Product Change Notification (PCN)

PCN Number: PCN_IndMAPI_20260901 Affected Series: WE-MAPI Affected Part Number: see table "PART NUMBER, REVISION & DATASHEET" PCN Date: 2026-06-01 (YYYY-MM-DD) Effective Date: 2026-09-01 (YYYY-MM-DD)	Change Category: ☐ Equipment/Location ☒ General Data ☐ Material ☐ Process ☐ Product Design ☐ Shipping/Packaging ☐ Supplier ☐ Software
Contact: Product Management Phone: +49 (0) 7942 - 945 5001 Fax: +49 (0) 7942 - 945 5179 E-Mail: pcn.eisos@we-online.com	Datasheet Change: ☒ Yes ☐ No Attachment: ☐ Yes ☒ No

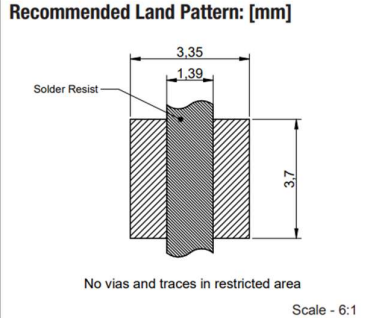
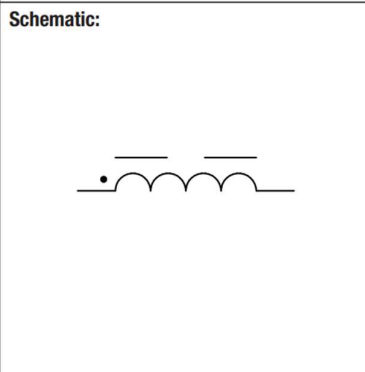
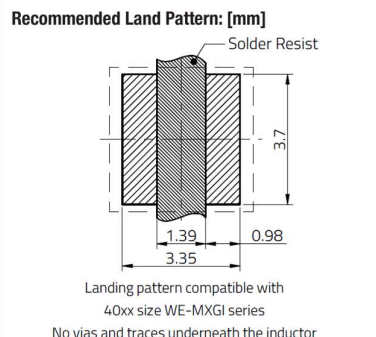
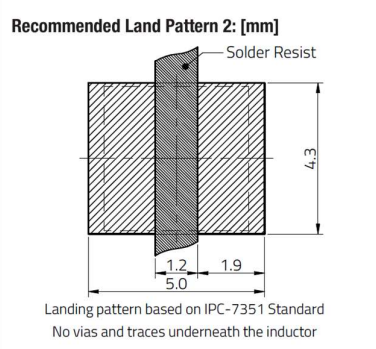
Size 4012	
Revision before change	Revision after change
Recommended Land Pattern: [mm]  No vias and traces in restricted area Scale - 6:1 Schematic: 	Recommended Land Pattern: [mm]  Landing pattern compatible with 40xx size WE-MXGI series No vias and traces underneath the inductor Recommended Land Pattern 2: [mm]  Landing pattern based on IPC-7351 Standard No vias and traces underneath the inductor

Size 4020 & 4020HT	
Revision before change	Revision after change
Recommended Land Pattern: [mm]  No vias and traces in restricted area. Scale - 6:1 Schematic: 	Recommended Land Pattern: [mm]  Landing pattern compatible with 40xx size WE-MXGI series No vias and traces underneath the inductor Recommended Land Pattern 2: [mm]  Landing pattern based on IPC-7351 Standard No vias and traces underneath the inductor

Size 4030											
Revision before change	Revision after change										
Recommended Land Pattern: [mm]  No vias and traces in restricted area Scale - 6:1 Schematic: 	Recommended Land Pattern: [mm]  Landing pattern compatible with 40xx size WE-MXGI series No vias and traces underneath the inductor Recommended Land Pattern 2: [mm]  Landing pattern based on IPC-7351 Standard No vias and traces underneath the inductor										
RELIABILITY / QUALIFICATION OF CHANGE: An additional reliability testing was performed and approved. Qualification according to AEC-Q200 table 5. Additional details of the tests can be found in the table below: <table><tr><th>Test Item</th><th>Sample size</th><th>Reference</th><th>Test conditions</th><th>Acceptance</th></tr><tr><td>Vibration</td><td>30</td><td>MIL-STD-202-204</td><td>5 g for 20 min, 12 cycles each of 3 orientations. Test from 10 Hz to 2000 Hz.</td><td>Approved</td></tr></table>		Test Item	Sample size	Reference	Test conditions	Acceptance	Vibration	30	MIL-STD-202-204	5 g for 20 min, 12 cycles each of 3 orientations. Test from 10 Hz to 2000 Hz.	Approved
Test Item	Sample size	Reference	Test conditions	Acceptance							
Vibration	30	MIL-STD-202-204	5 g for 20 min, 12 cycles each of 3 orientations. Test from 10 Hz to 2000 Hz.	Approved
